UNITED STATES
DEPARTMENT OF THE INTERIOR
BUREAU OF LAND MANAGEMENT

SUNDRY NOTICES AND REPORTS ON WELLS
Do not use this form for proposals to drill or to re-enter an abandoned well. Use form 3160-3 (APD) for such proposals.

8. Well Name and No.
HH SO 8 P2 5H

Changes to APD for Federal Wells

TA Cap, EBS-F-RM, 9°
13-5/8" SM
Part # 399984 - Rental

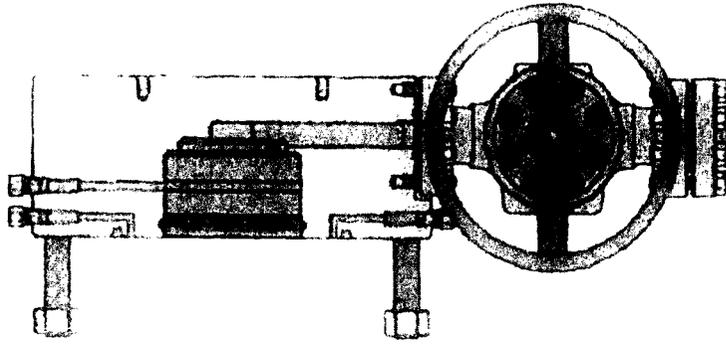
1. Drill 17-1/2" surface hole with fresh water to planned casing set depth with 10' rat hole.
2. Run casing as stated by approved APD, land out wellhead, and cement.
3. Dress out 13-5/8" 5M SH-2 wellhead and install/secure with temporary abandonment cap, and a pressure gauge will be installed. Reference image below *Part U 399984*
4. Skid to next well according to below "Drill Order"
Repeat 1 through 3 until all six surface holes are drilled, cased and cemented

- a. In the event the operator has proposed to drill multiple wells utilizing a skid/walking rig. Operator shall secure the wellbore on the current well, after installing and testing the wellhead, by installing a blind flange of like pressure rating to the wellhead and a pressure gauge that can be monitored while drilling is performed on the other well(s).
